Alameda Point - Site A • Waterfront Park • PHASE I

SUBSTANTIAL CONFORMANCE EXHIBITS: RECREATION & PARK COMMISSION | OCTOBER 10, 2019

PROPOSED SITE PLAN CONCEPT

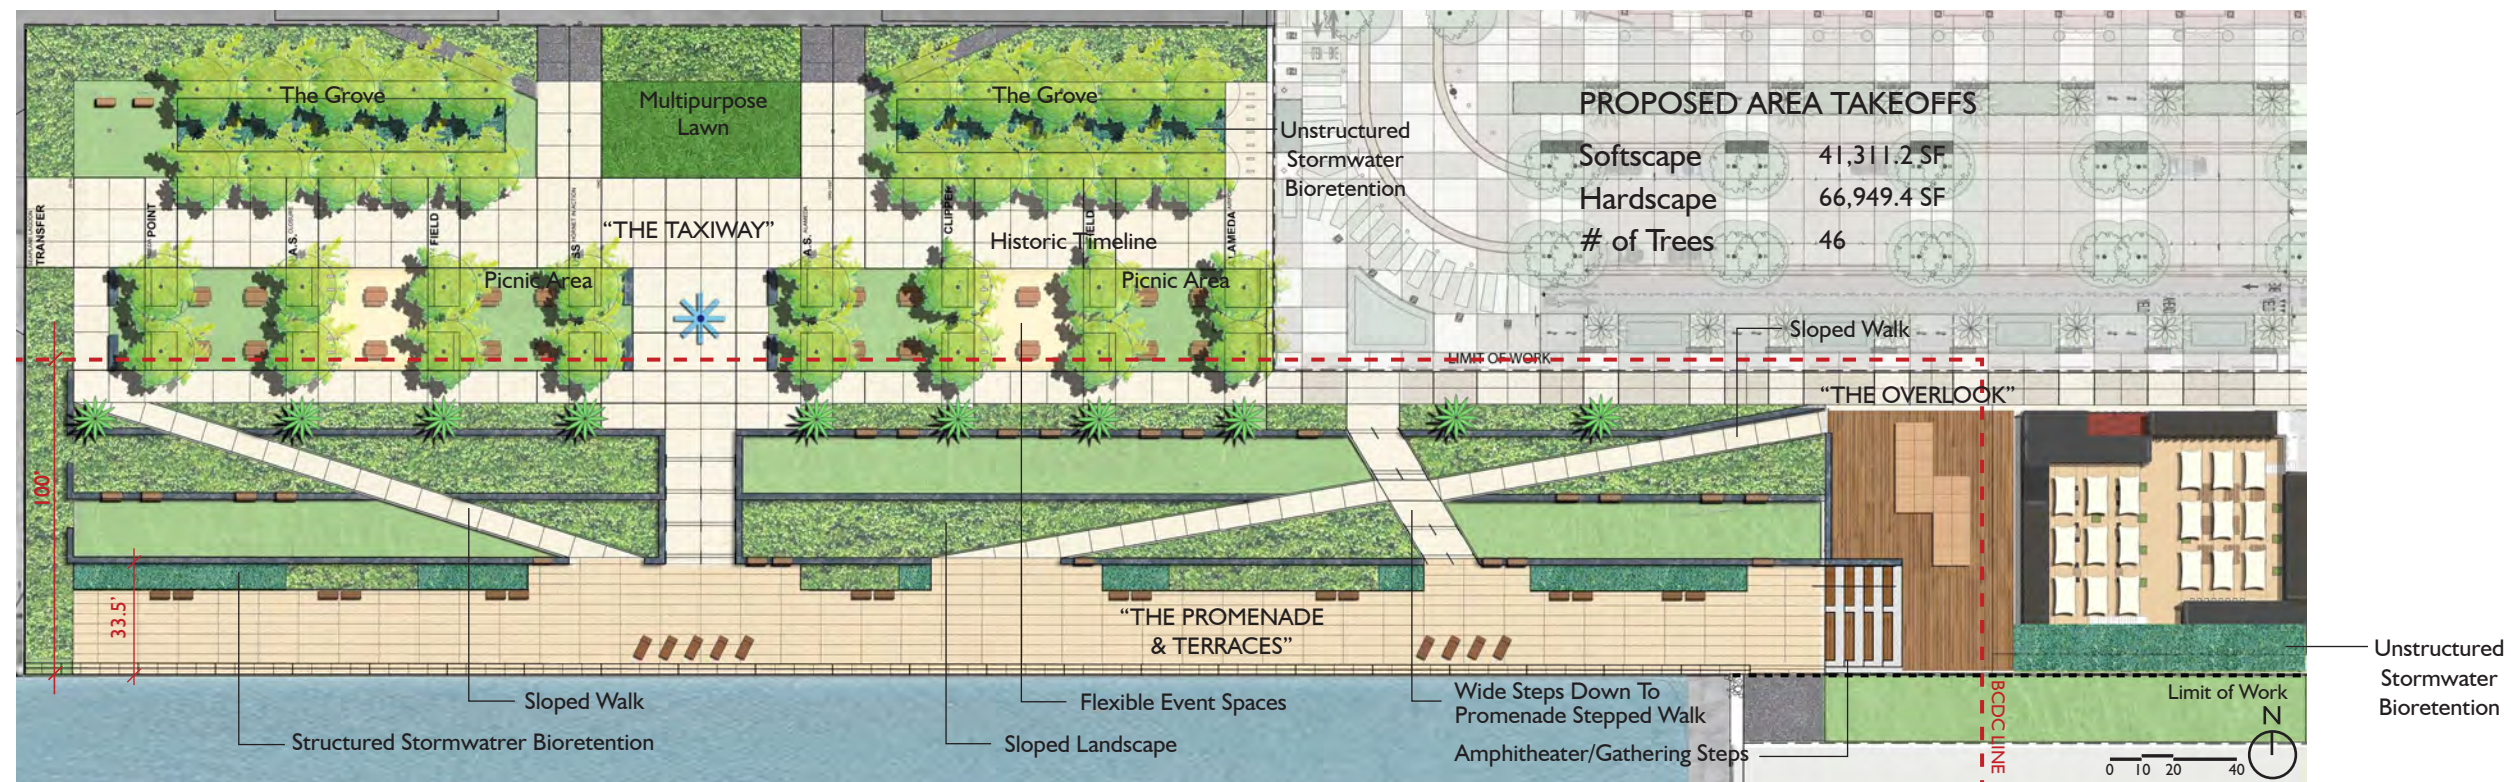
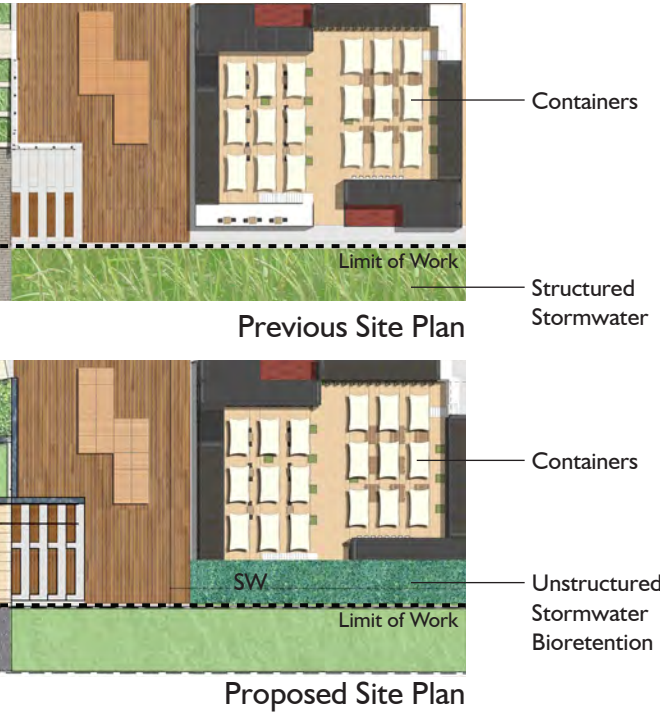
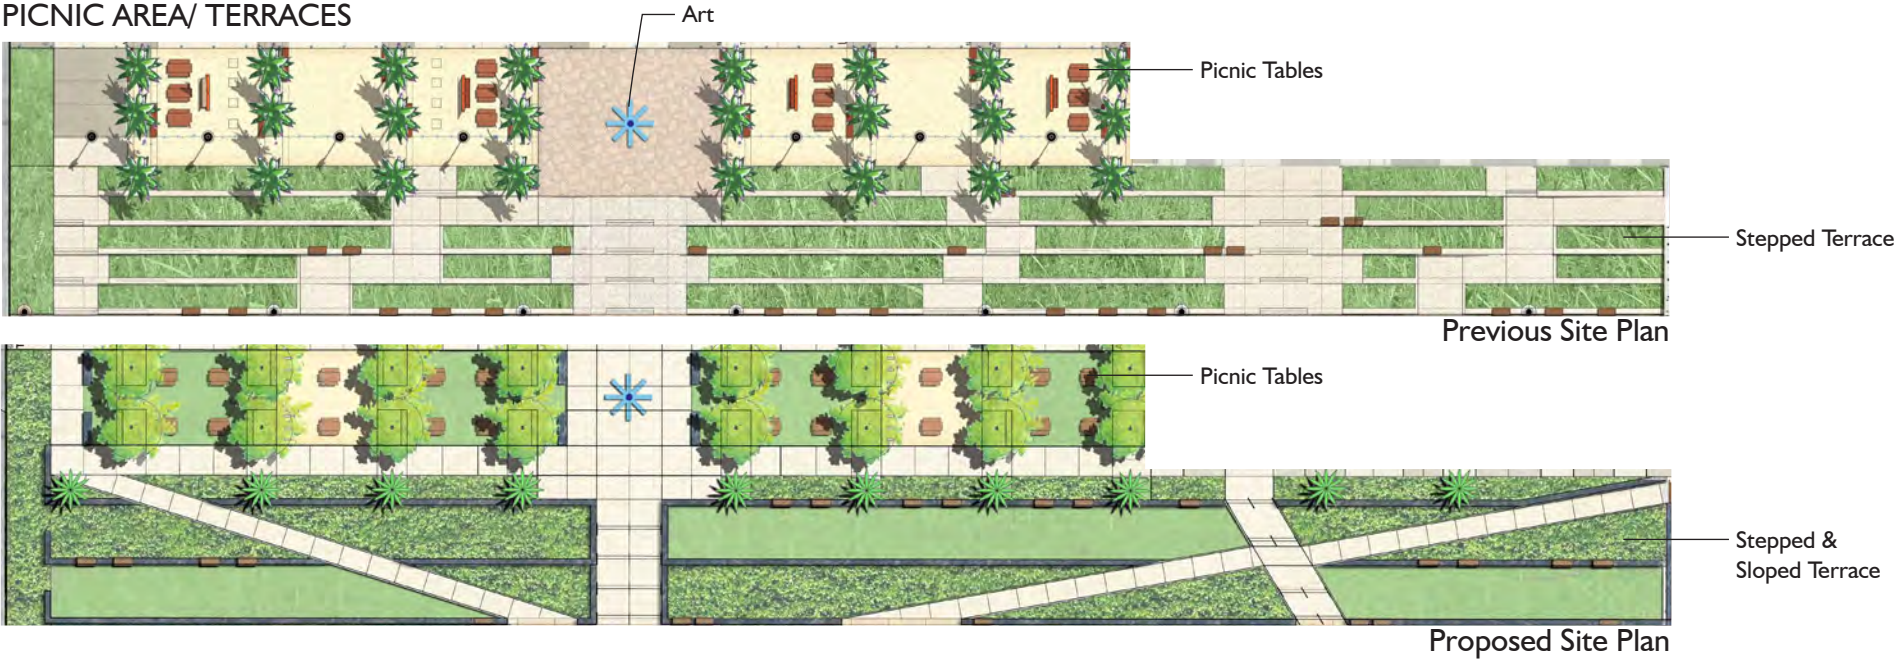
PREVIOUS SITE PLAN CONCEPT

SECTION A: Through Previous Plan

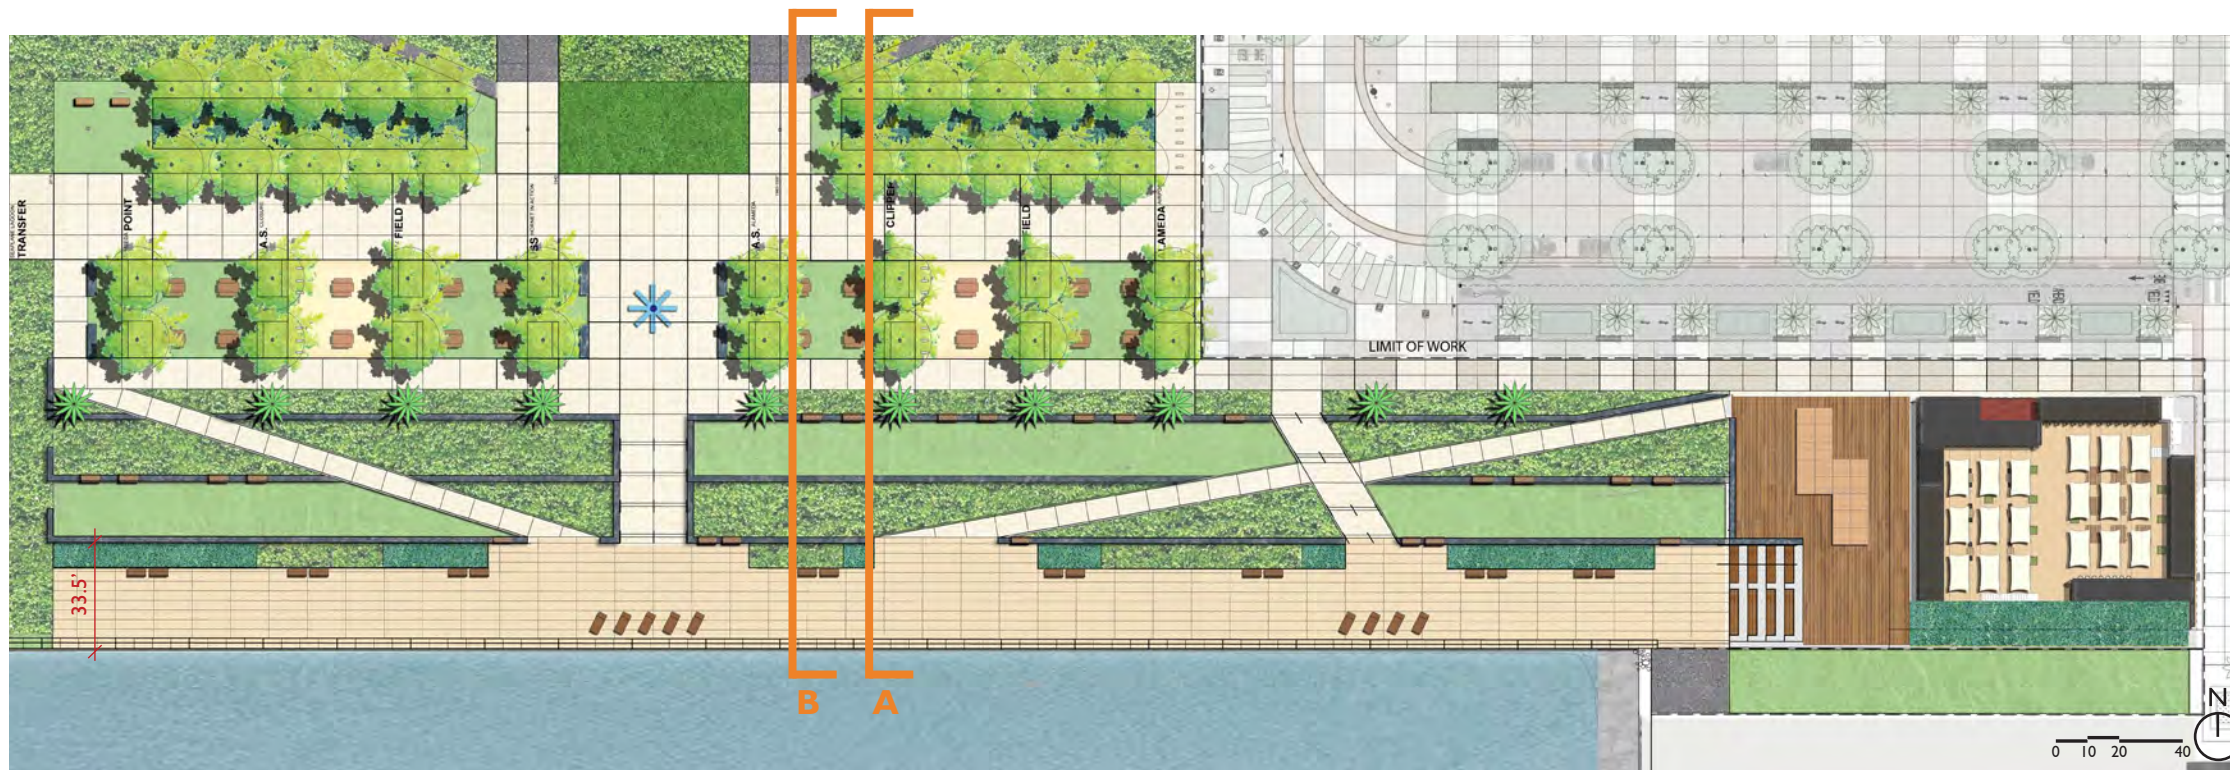
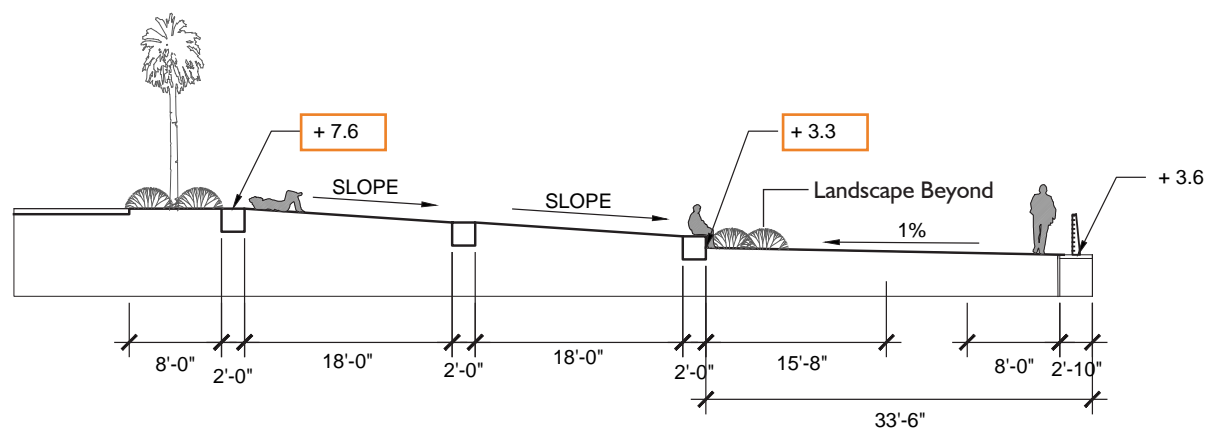
SECTION A: Through Proposed Plan

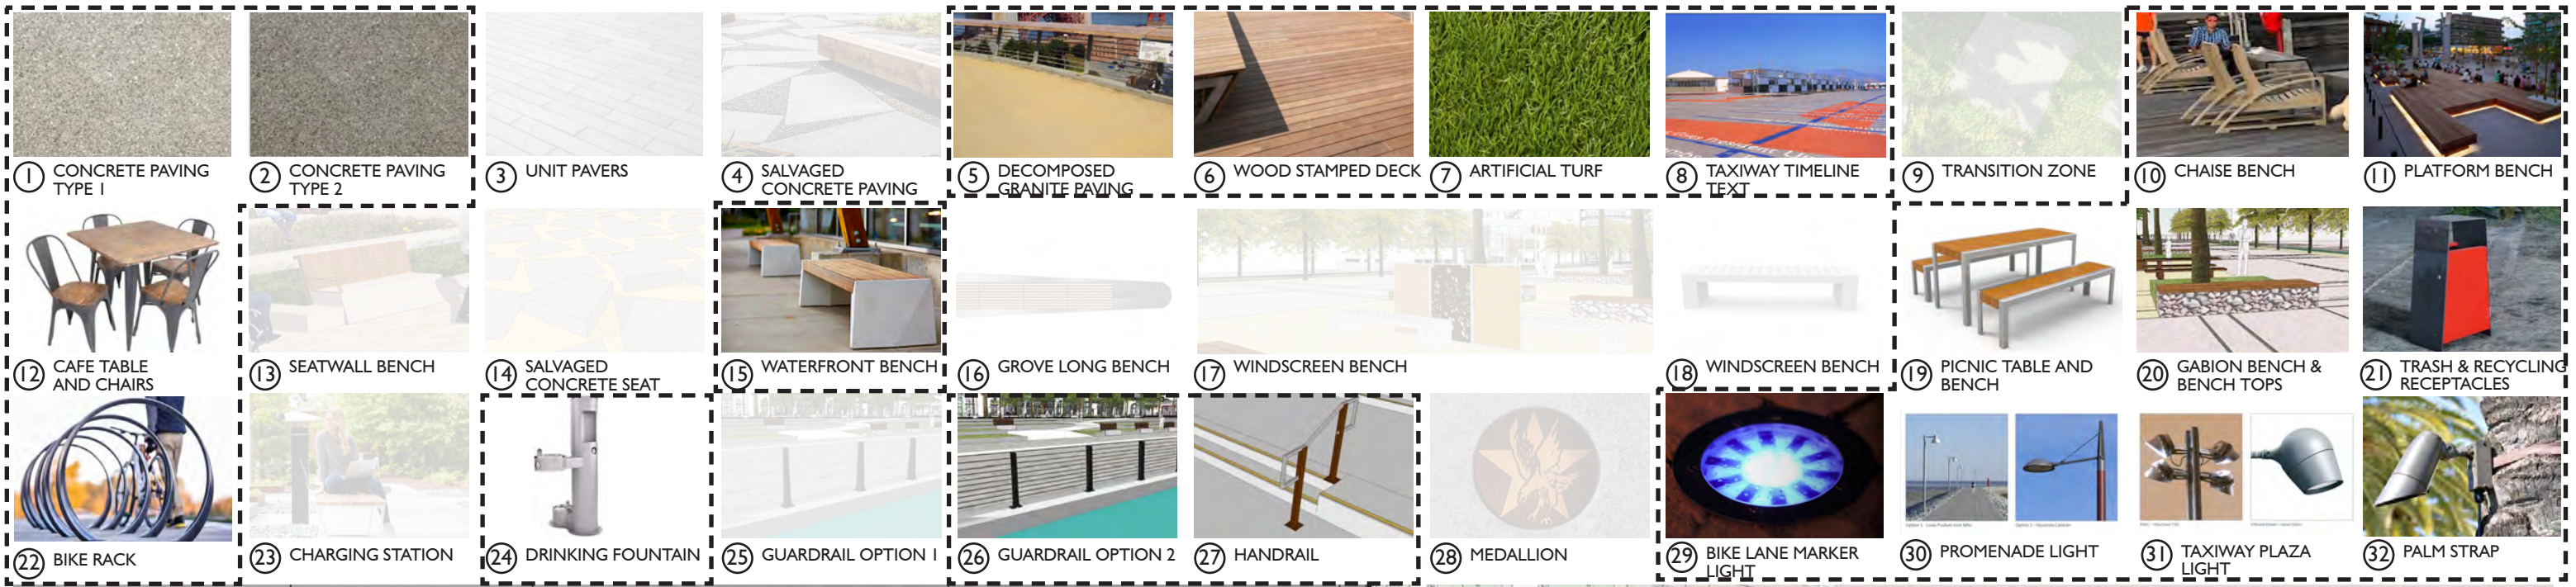
WAS THIS:

Washingtonia robusta
Mexican Fan Palm:

- These palms are completely suited to the coastal climate
- These palms are readily available in the quantities that we need for the Waterfront Park, but also additionally for the Shared Street and West Atlantic Drive
- They are very affordable
- These palms grow to be too tall for human scale, ultimately 90-120 feet
- They grow at 2 feet per year, so in 20 years they will be 60 feet tall

NOW THIS:

Livistonia australis
Cabbage Tree Palm :

- These palms are suited to the coastal climate
- It looks like a Fan Palm
- Matches shared plaza palm

NOW THIS:

Robinia 'Purple Robe'
Purple Robe Honey Locust:

- Will grow 30 - 40 feet high and 20 - 30 feet wide
- Excellent shade tree
- Has deciduous foliage
- Drought tolerant
- Suitable for seaside regions
- Fragrant flower
- Fall color
- Tree selection for Orion Street at Alameda Point

OR THIS:

Quercus shumardii
Shumard Oak:

- Will grow up to 60 feet high and 50 feet wide
- Excellent tall shade tree
- Deciduous dark green foliage throughout the season
- On Recommended Park Tree List
- Suitable for seaside regions
- Desirable wildlife plant

31 TAXIWAY PLAZA POLE AND FIXTURE

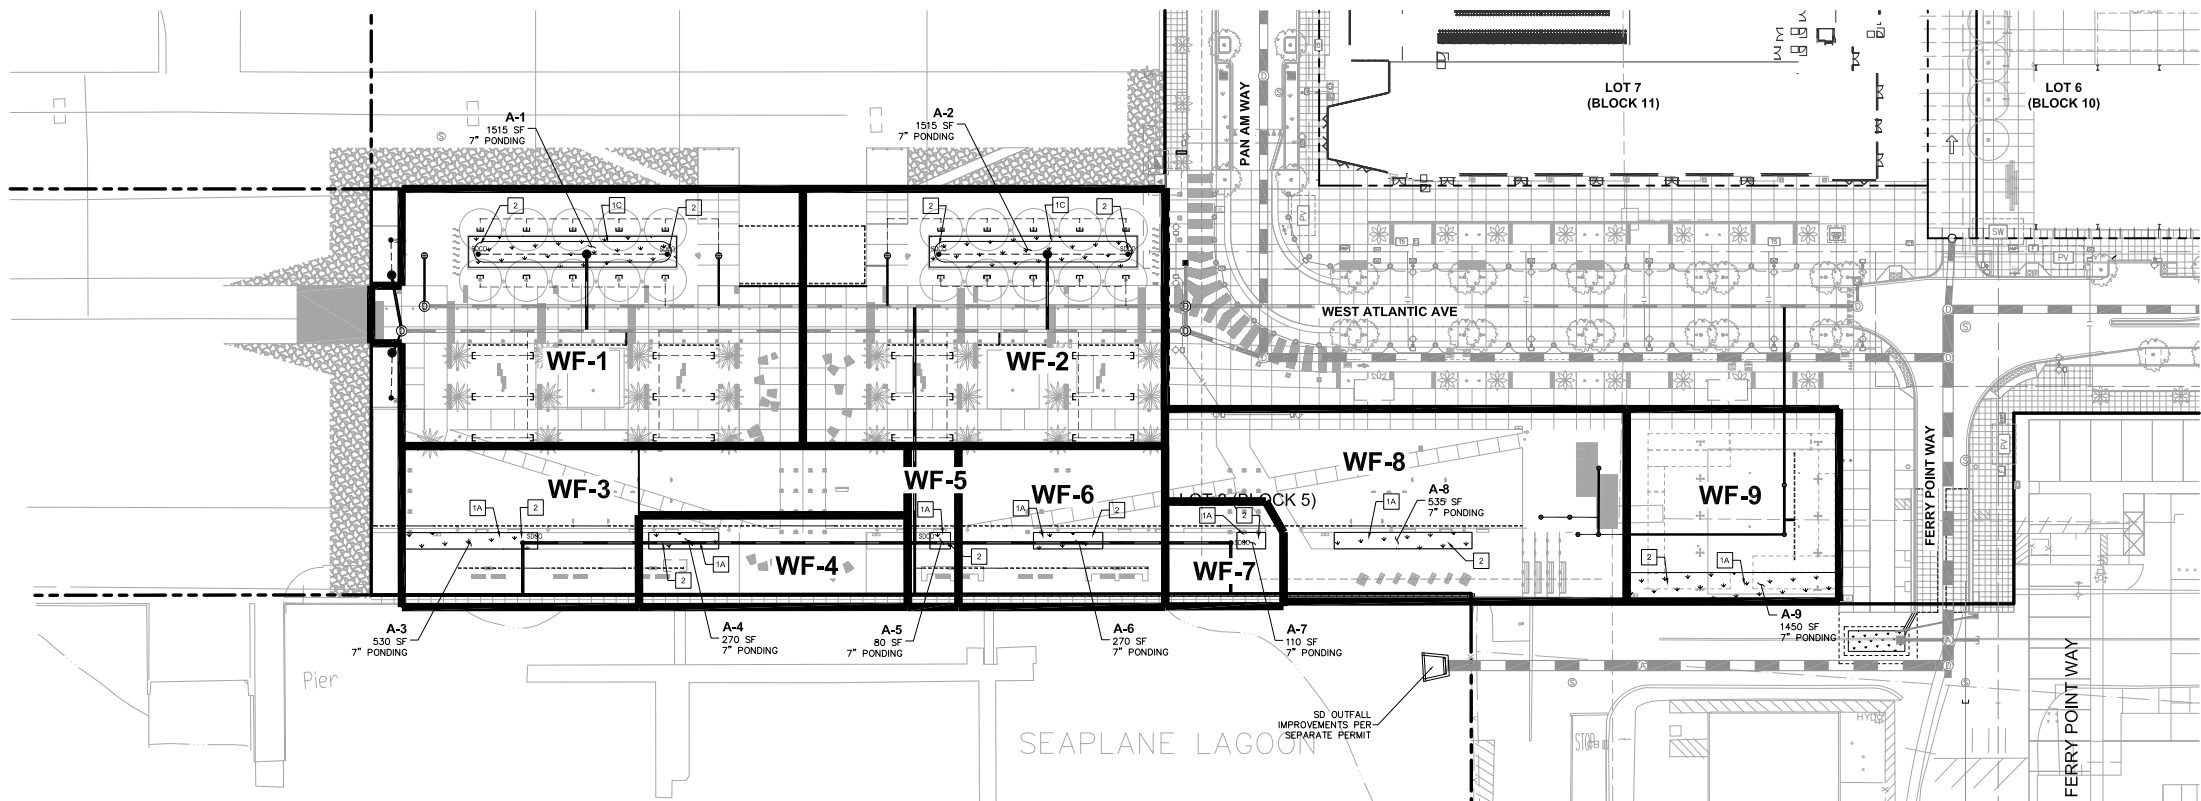
NOTE: NUMBER OF FURNITURE AND MANUFACTURERS HAVE CHANGED. CONCEPT REMAINS.
